Greater Cambridge Design Review Panel

Meeting Notes Confidential

Project name: The Beehive Centre redevelopment

Pre-Application Reference: 23/03204/OUT

Townscape and Heritage Enhancements Coldhams Common B - Amended

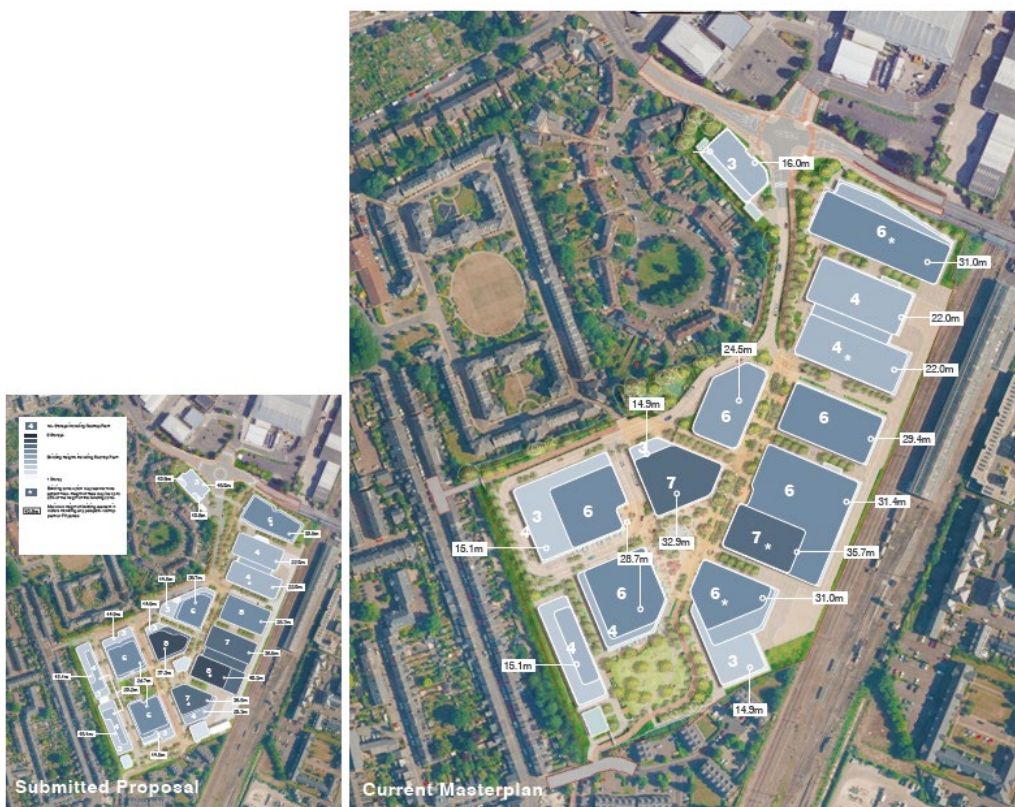
- 1) The new layout is much simpler and much more legible.
- 2) The bulk of Plot 2 against Coldham's Lane is still excessive (refer to page 15) and is prominent in the views. It looks at least 2 storeys too tall. Previously the idea of massing was explained as building up to the centre (around Plots 4 and 5) and dropping down to the south next to residential neighbours and to the north against the main road. The building on Plot 2 'kicks up' at the end of the north-south view, so that it breaks the pattern of massing.
- 3) To avoid the rooflines of plots 3,4,5 appearing as a single mass (p137) when seen from a distance stronger design measures than just change of colours, materials or sawtooth outlines are needed. It is strongly recommended that the plant screens be better

Plot 2 is highly visible in the views from Castle Hill Mound (p127) and Coldham's Common (p128) as it 'kick's up' at the end of the north-south sequence of massing. Plot 7's relationship with the adjacent housing has improved but could still move away from the boundary. Are there issues of overlooking from the roof terraces, as Plot 7, 9 and 6.
